TOLEDO-LUCAS COUNTY PLAN COMMISSIONS

DATE: July 12, 2019
REF: SUP-10010-13

SUBJECT: Review of Possible Revocation of the Special Use Permit for a Used Auto Sales Facility approved via Ord. 70-14. at 4154, 4158 & 4160 Monroe Street.

SITE PLAN

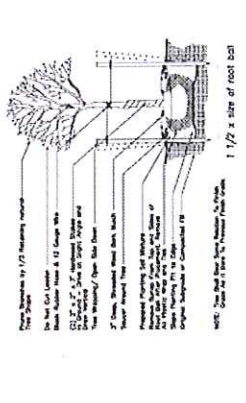
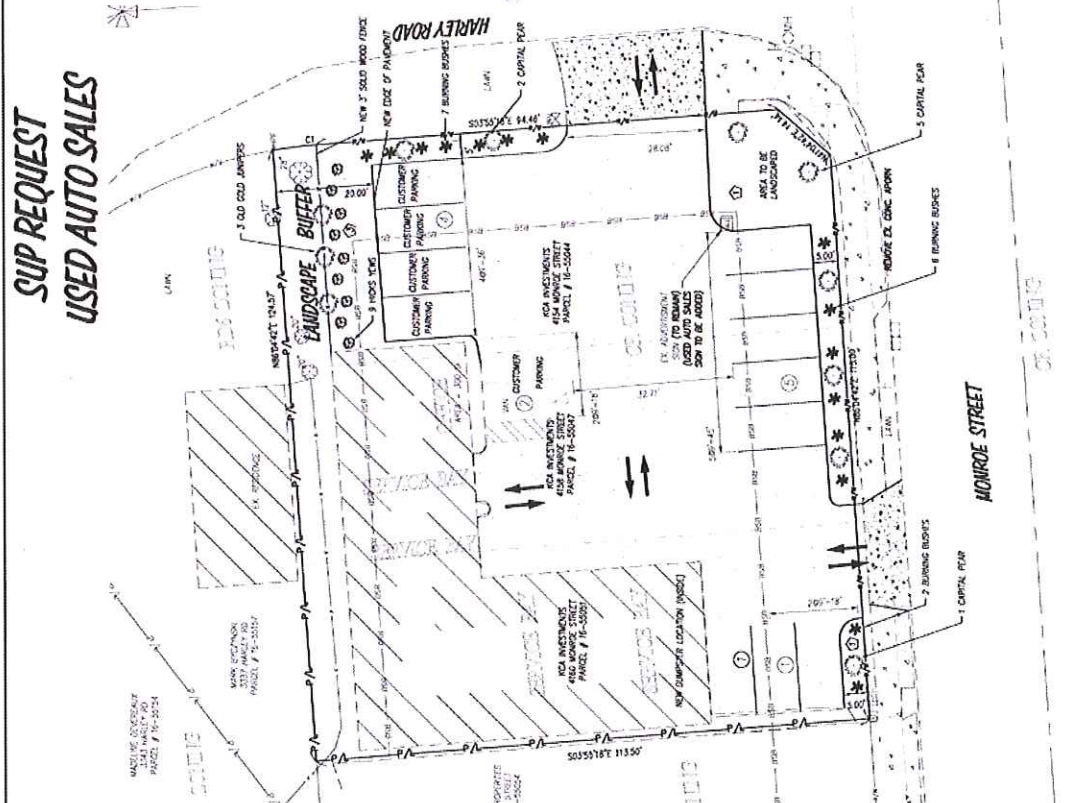
Outlined in the March 10, 2016 staff report, the Division of Transportation had conditions that required the remaining curb cut along Monroe Street to be narrowed to twenty-five (25) feet and shifted eastward to prevent a conflict with the parking spaces in the northwest corner of the site along Monroe Street. The Division of Transportation also required that the curb cut along Harley Road be narrowed to twenty-five (25) feet to reduce the conflict with the existing pole sign and to increase the distance from the Monroe Street/Harley Road intersection. On June 19, 2019, staff noted that none of these conditions have been addressed. **As a result, Conditions # 1, #2, #3, #4, #13 & #14 are still not in compliance with requirements of the Division of Engineering Services and the Division of Transportation.**

Light equipment repairs have a parking requirement of 1.5 spaces per service bay, while the used car sales portion of the site has a parking requirement of one (1) space in addition to the seven (7) defined parking spaces for display vehicles. As a result, the applicant was required to dedicate seven (7) total customer and employee parking spaces for the light equipment repairs and used car sales uses on site. As part of the June 19, 2019 inspection, staff found that cars were once again being double and triple parked, parked in unapproved areas and parked in the drive aisles. The applicant requested that staff perform a compliance inspection on June 28, 2019. Staff visited the site on June 26, 2019 and found that cars were still located within the drive aisles and being double and triple parked. Furthermore, the applicant was required to denote a minimum of seven (7) spaces for customer use and the use of signage is encouraged to ensure customer parking is maintained. **As a result, Condition # 18 has not been brought into compliance.**

TMC§1104.0301 requires that a fifty (50) foot separation measured along the street frontage shall be maintained between any open display area and a residential district boundary line. The northeast corner of the property (with fifty (50) feet of residential boundary) was approved for customer and employee parking and not open display areas. As part of the June 19 & 26, 2019 site inspections, staff observed licensed and unlicensed vehicles double and triple parked and located within the drive aisles. The applicant indicated that he works on vehicles for other used car dealers and most of the vehicles on the site were not for sale. Storage of vehicles (for sale or not for sale) in undesignated spots has created a blighting nuisance condition that has had a negative impact on the residential neighborhood abutting the site to the north as well as along Monroe Street. **Upon the compliance inspection on June 19 & 26, 2019, staff found no evidence that seven (7) parking spaces had been denoted for customer and employee parking with signage or were even being used for customer and employee parking. As a result, Condition # 19 has not been brought into compliance.**

At the time of the 2014 approval, the site was only required to be brought closer into compliance with the landscape requirements of the zoning code. The revised plan offered a twenty (20) foot Type "A" Landscape Buffer with a three (3) foot solid fence along the northern property line, where the site abuts residential zoning. In an effort to install this buffer, the applicant was to remove approximately eleven (11) feet of asphalt and the fencing was to be raised to six feet (6') once located out of the front yard setback. Upon the compliance inspection on June 10, 2016 & June 19, 2019, staff found that a forty-two inch (42") solid fence and a planting bed had been installed. However, at the July 14, 2016 Plan Commission Hearing, the applicant was instructed to remove the forty-two inch (42") and replace it with a six (6') solid fence (when located out of the front yard setback) in order to obtain compliance with Condition #23. **Condition # 23(b) has not been brought into compliance with the Type A Landscape Buffer requirement, fencing needs to be raised to six feet (6') when located out of the front yard and the asphalt needs to be removed beneath the planting beds to provide an adequate growing environment.**

Additionally, the site plan offered a landscape area anchoring the corner of Monroe Street and Harley Road and five (5) foot greenbelts along Monroe Street and the Harley Road frontages. The applicant installed planting beds along Monroe Street and Harley Road according to the approved plan. Staff has concerns that the asphalt located beneath the planting beds was not removed, resulting in a less than ideal environment for tree and shrub growth. The March 10, 2016 staff report indicated that the six (6) inch planting beds appeared to be located over asphalt and that was not a conducive environment for trees and/or shrubs to grow according to the City of Toledo Division of Forestry. The applicant indicated that three feet (3') x three feet (3') sections of asphalt were removed beneath the newly installed trees and ensured the landscaping would be maintained indefinitely. As previously noted on June 19 and 26, 2019 the required planter beds appeared to be in poor condition with numerous areas being breached and other areas where vehicles were currently parked in a way that was damaging the planter bed. Furthermore, by not properly preparing the landscape beds when installed (not removing all asphalt) resulted in all hosta & ornamental grasses perishing, detracting from the aesthetics of the buffer.

Although the applicant has taken steps to comply with the landscaping requirements outlined in Ord. 70-14, staff has found that not removing the entire asphalt beneath the planting beds did not provide a suitable environment for landscaping to grow and thrive. The approved landscape plan submitted in 2014 indicated that three (3) Junipers and nine (9) yews were to be installed within this northern buffer. Staff found that six (6) shrubs of approximately forty-two (42") inches in height were located within this buffer. Furthermore, the planting beds did not appear to be finished with properly maintained mulch as required by code. **Condition # 23(a)(b)(c)&(e) is not in compliance as the Type A Buffer along the northern property line does not contain the required plantings as shown on the landscape plan. In addition the beds are sited over existing asphalt, providing an unfavorable environment for tree and shrub growth and all landscaped areas need to be finished with properly maintained mulch.**
